Portland General Electric Company

Trojan Nuclear Plant
Docket 50-344
License NPF-1

Attached is our response to your letter of October 1, 1979 relating to the generic issue of degraded grid voltage as it applies to the Trojan Nuclear Plant. Please note that we have responded item by item to each one of the NRC positions provided in Enclosure 1 to your June 3, 1977 letter.

PROPOSED NRC RESPONSE

FIGURE 1. PROPOSED UNDERVOLTAGE PROTECTION SCHEMES

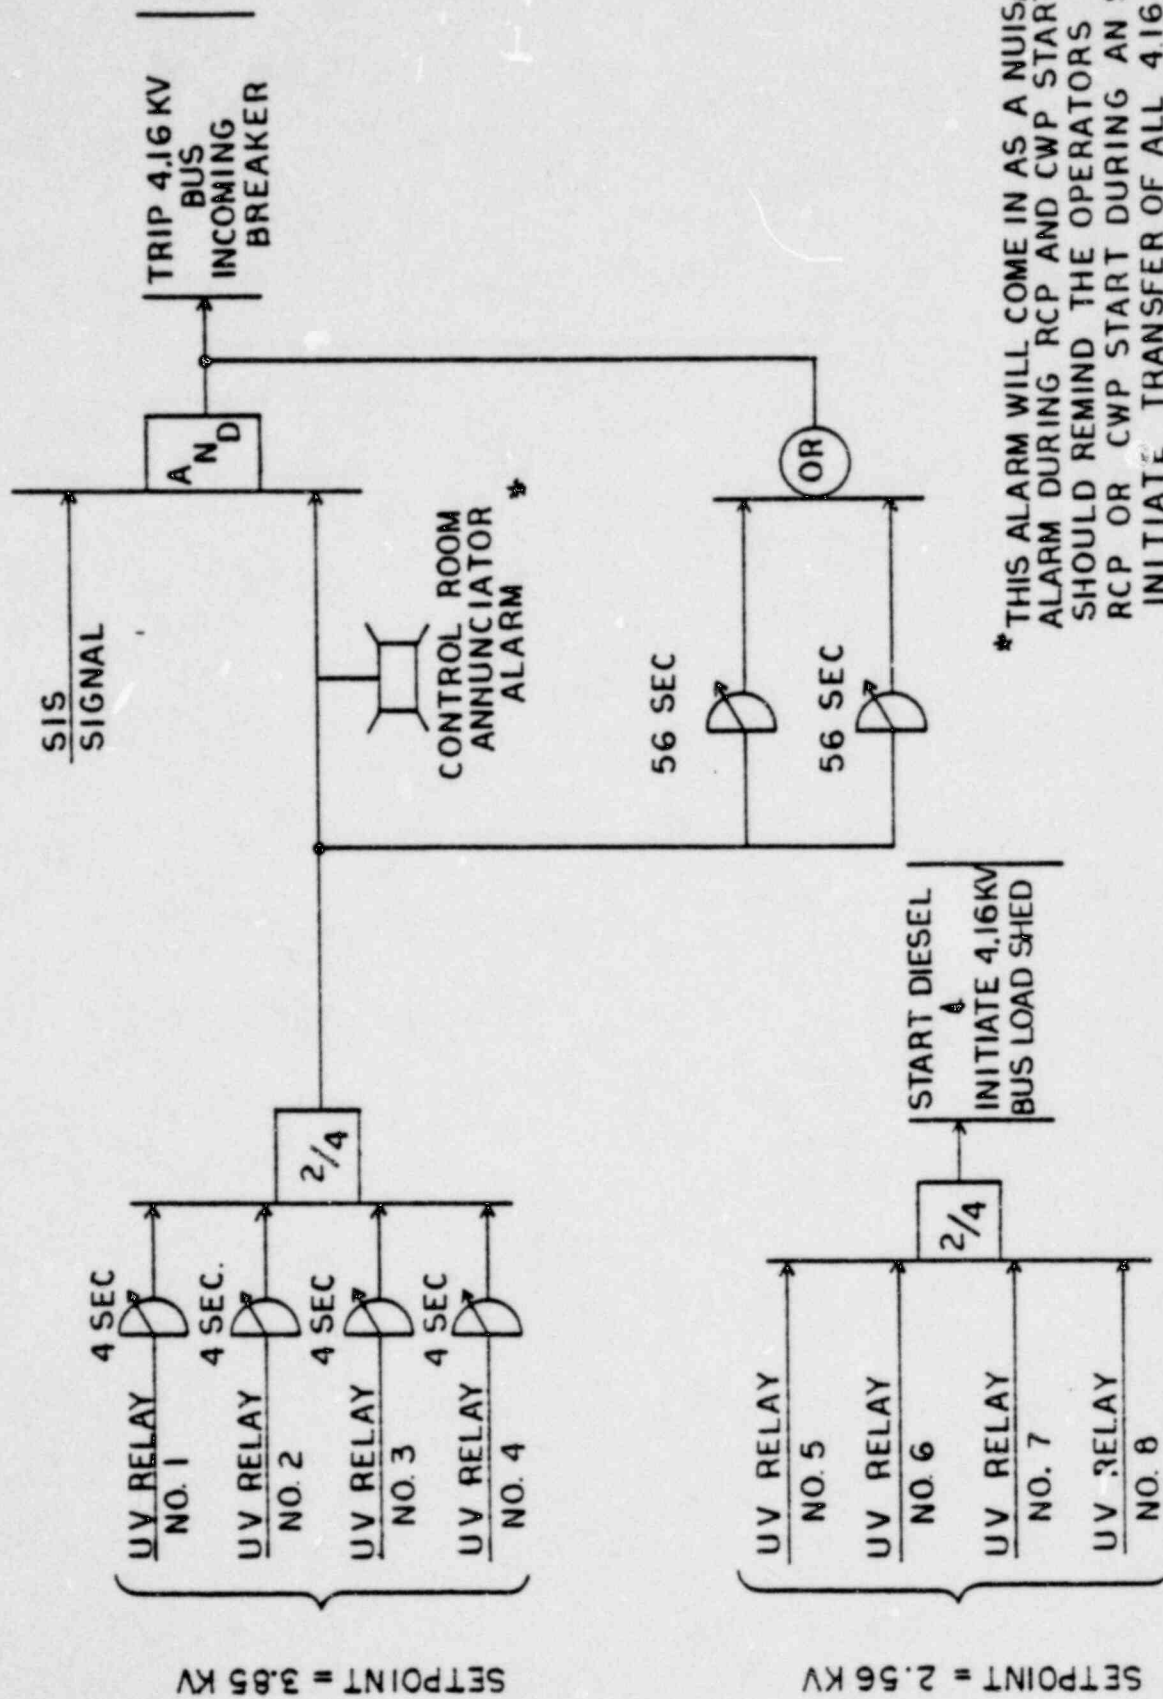
We require that a second level of voltage protection for the onsite power system be provided and that this second level of voltage protection shall satisfy the following criteria:

- b) The voltage protection shall include coincidence logic to preclude spurious trips of the offsite power source;
- c) The time delay selected shall be based on the following conditions:

- d) The voltage monitors shall automatically initiate the disconnection of offsite power sources whenever the voltage set point and time delay limits have been exceeded;

A second level of voltage protection for the onsite power system will be provided. This level will consist of a set of four solid-state definite time (4-sec time delay) undervoltage relays and two timers (set for 56-sec time delay) connected to each of the two 4.16-kV ESF buses. Coincidence logic will be used as shown in Figure 1. The relays and timers operate to achieve an output as follows:

1. If a safety injection signal (SIS) is present and two of the 4 sec level undervoltage relays operate, the normal 4.16-kV ESF bus feeder breaker (see FSAR Figure 8.3-1; breakers 152-101 and 152-201) will be tripped unless the undervoltage condition corrects itself within 4 sec. Tripping the feeder breaker causes a loss of voltage on the bus. The existing undervoltage protection relays will operate to start and connect the diesel generator to the bus and begin sequencing on the DBA loads.

2. If an SIS is not present and two of the 4-sec level undervoltage relays and one of the two timers operate, the normal 4.16-kV ESF bus feeder breaker will be tripped unless the undervoltage condition corrects itself within 60 sec.

Spurious trips on both first-level and second-level undervoltage protection schemes are minimized by using, in each case, four undervoltage relays whose outputs are connected in coincidence logic. The coincidence logic requires two out of the four relays to trip before any protective action is taken. The two undervoltage protection schemes are described below:

- a. The existing two out of two undervoltage protection scheme on each 4.16-kV ESF bus, presently set to load shed its bus and start its diesel generator at 2.56 kV, will be replaced with four undervoltage relays, all set at 2.5 kV. Operation of two of the four undervoltage relays will cause a bus load shed and diesel start as shown on Figure 1.
- b. The new second-level undervoltage protection scheme will consist of four definite time undervoltage relays, all set at approximately 3.85 kV (4-sec time delay to operate after pickup) and two 60 sec time delay relays, set for a 56 sec time delay. Operation of two of the four undervoltage relays will energize the two time delay relays. The normal ESF 4.16-kV bus feeder breaker will then be tripped if the undervoltage condition persists: 1) immediately if an SIS exists or 2) after at least one 56-sec timer has operated.

As described above, the undervoltage relay and timer outputs will use coincidence logic (two out of four and one out of two) to automatically initiate disconnection of the offsite power source via a trip of the normal 4.16-kV ESF bus feeder breakers when the undervoltage setpoint and time delay limits have been exceeded.

* THIS ALARM WILL COME IN AS A NUISANCE ALARM DURING RCP AND CWP START. IT SHOULD REMIND THE OPERATORS THAT A RCP OR CWP START DURING AN SI WILL INITIATE TRANSFER OF ALL 4.16KV ESF LOADS TO THE DIESELS.
